Appendix I of RNTPC
Paper No. A/I-LI/33

PWP Item No. 4355DS
Outlying Islands Sewerage Stage 2 - Lamma Village Sewerage Phase 2 Package 2A

Planning Application under Section 16 of Town Planning Ordinance
for Tai Wan To Sewage Pumping Station

Landscape Master Plan

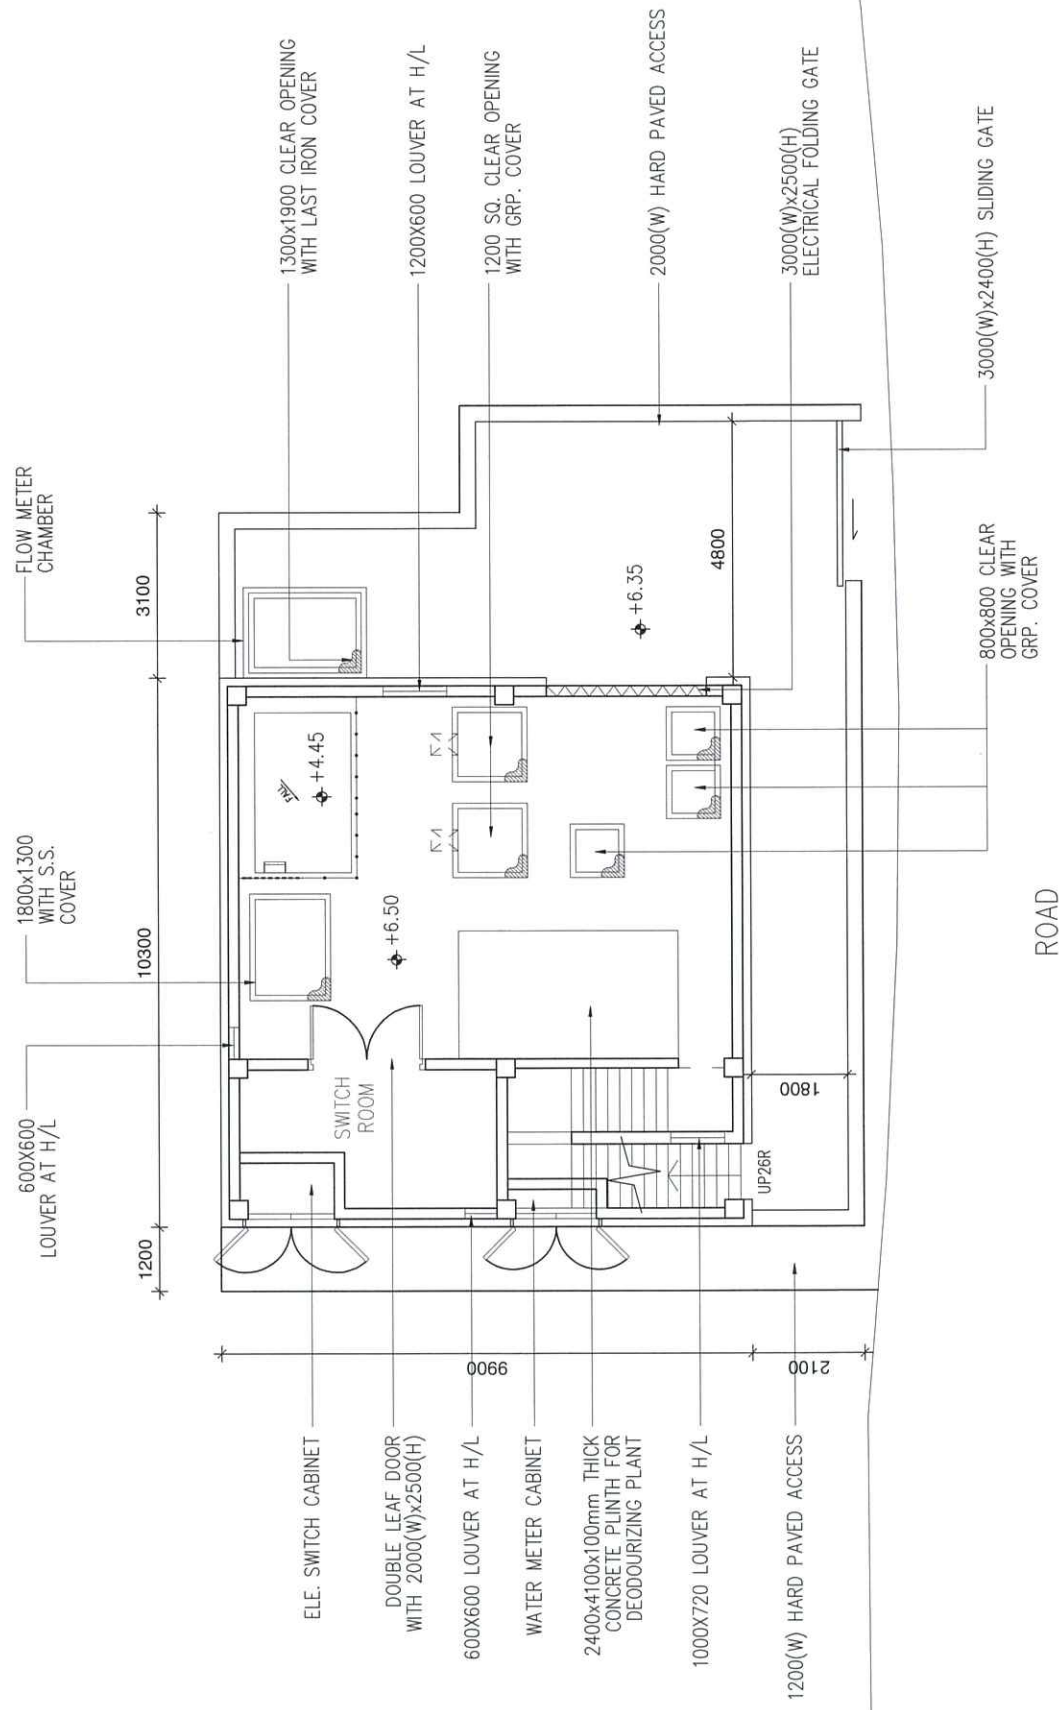
2) As shown on Fig. 2.1 in the submitted Planning Statement, about 19 pieces of PV solar panel would be installed on the roof of the proposed development. The PV solar panels are to provide renewable energy solely for the operational use of the proposed development.

General Arrangement (Ground Floor)

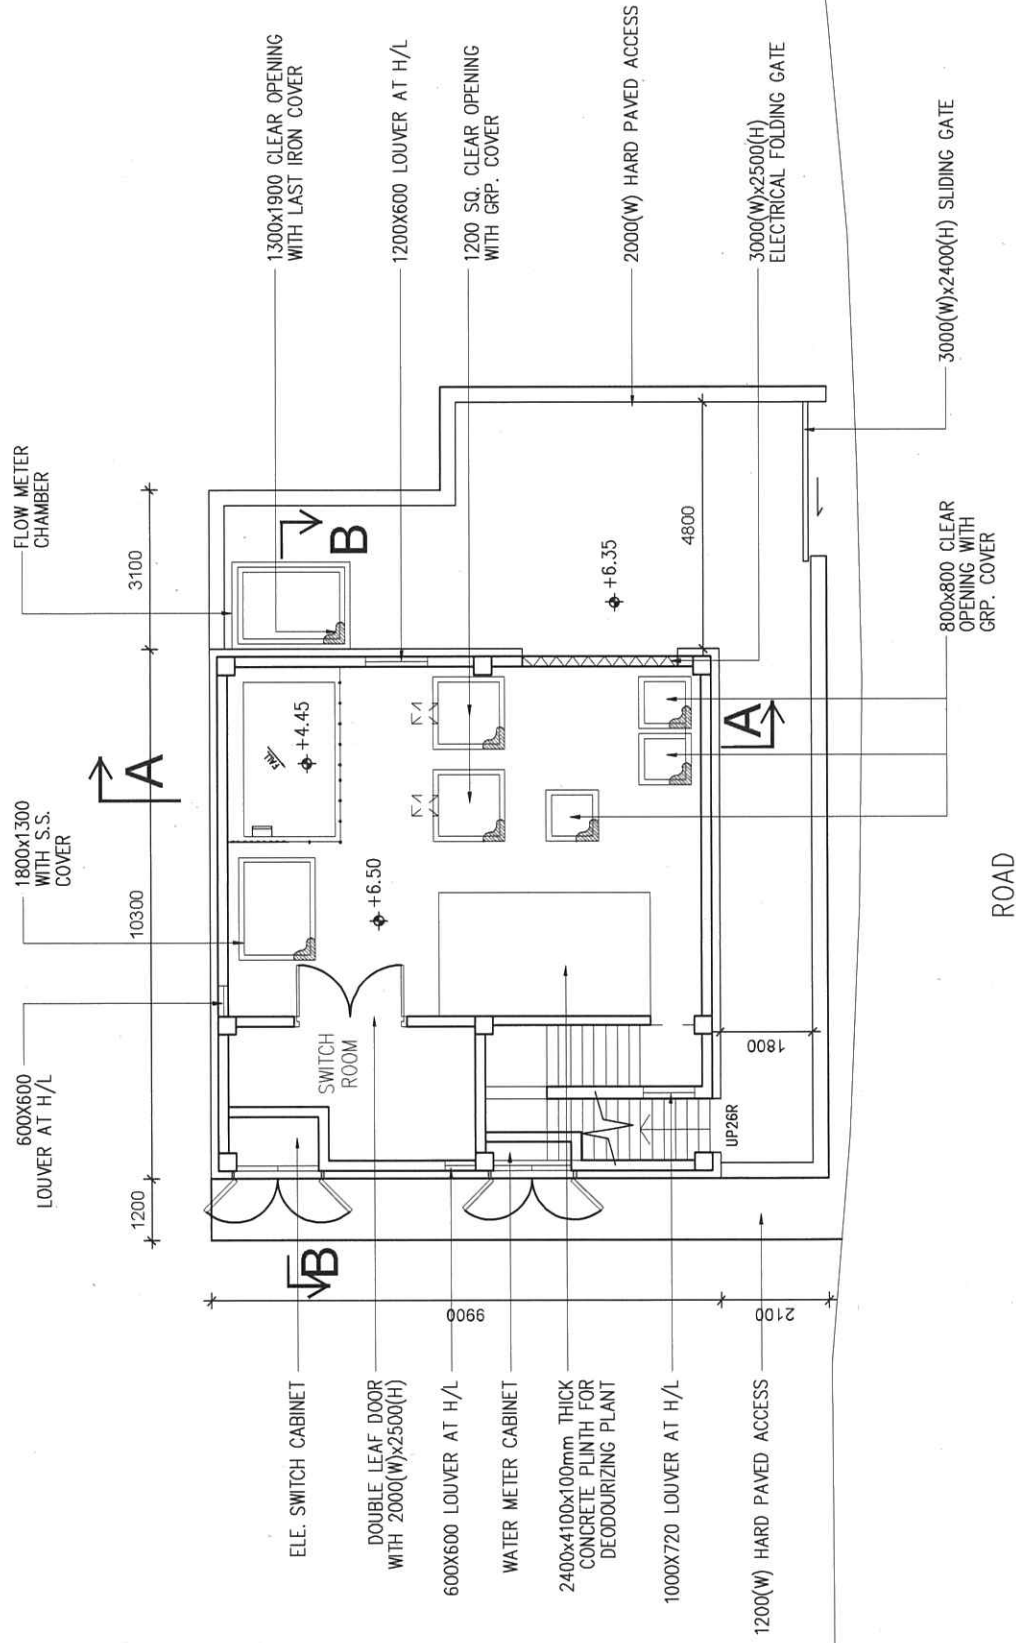
3. Bottom of the basement is about 8.7m from the existing ground. I attach the basement layout plan at Annex A.

Elevation A

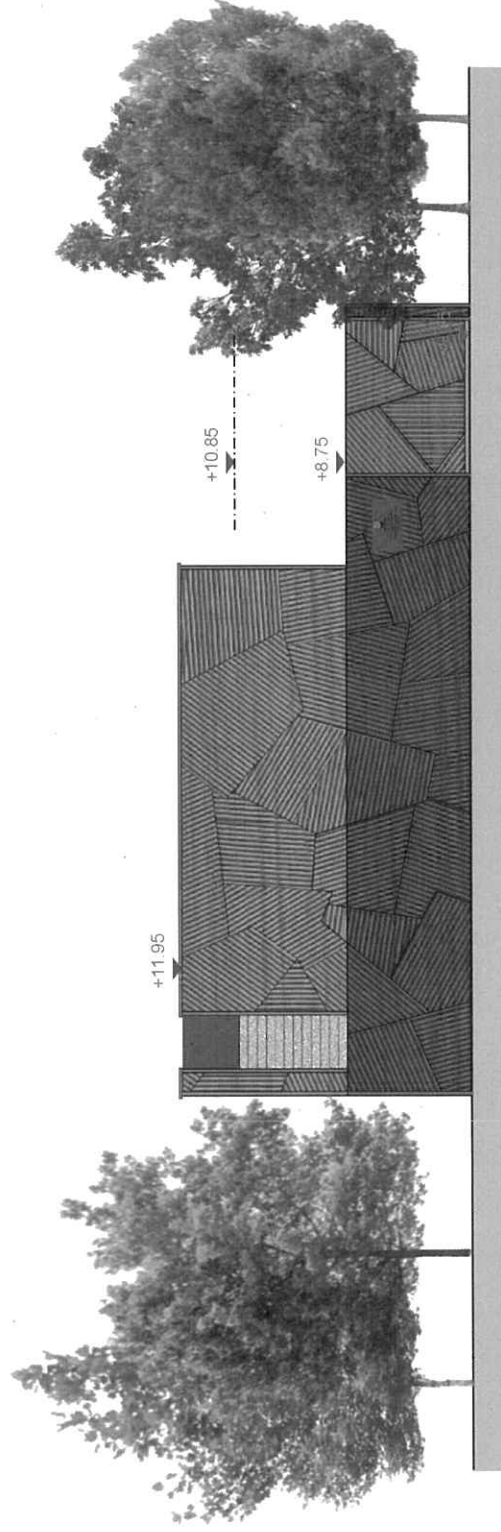
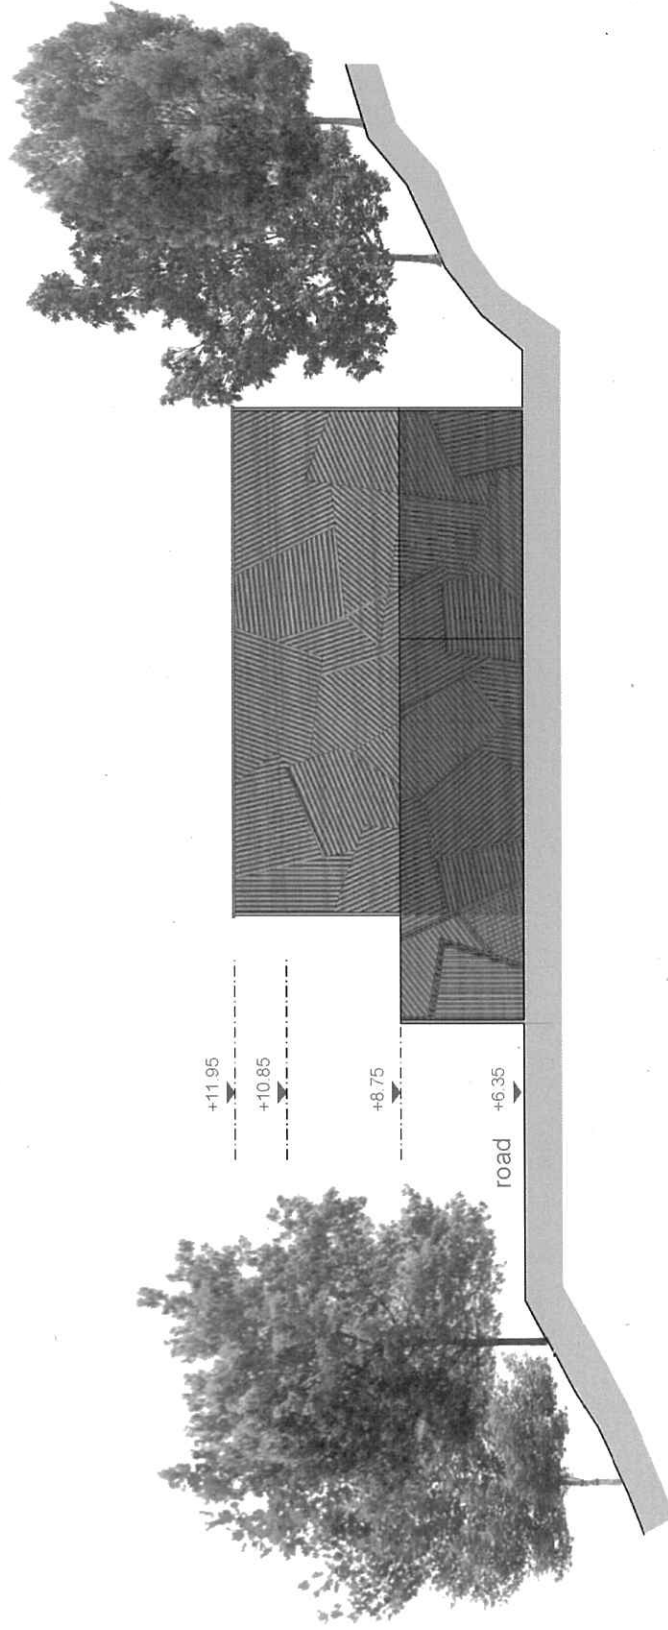
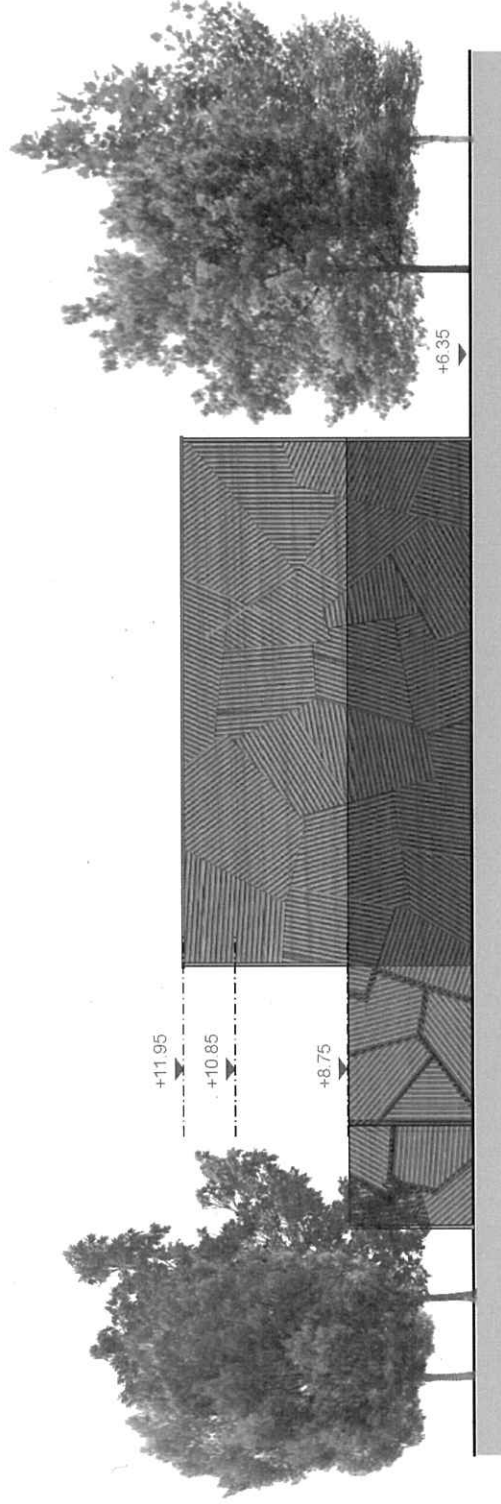
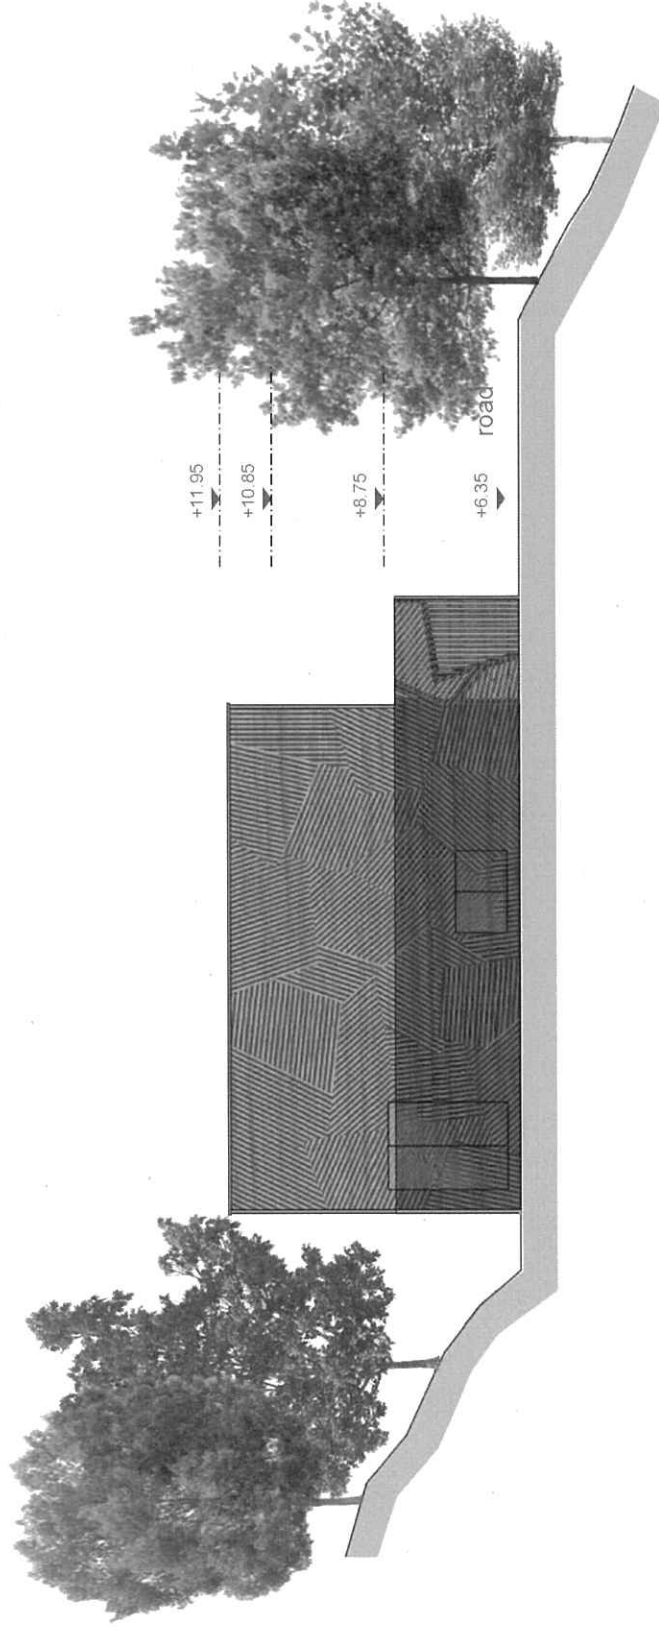
5. A graphic error was spotted in Elevations A to D in the enclosure 2 of the submitted planning statement. I attach the revised elevations at Annex C.
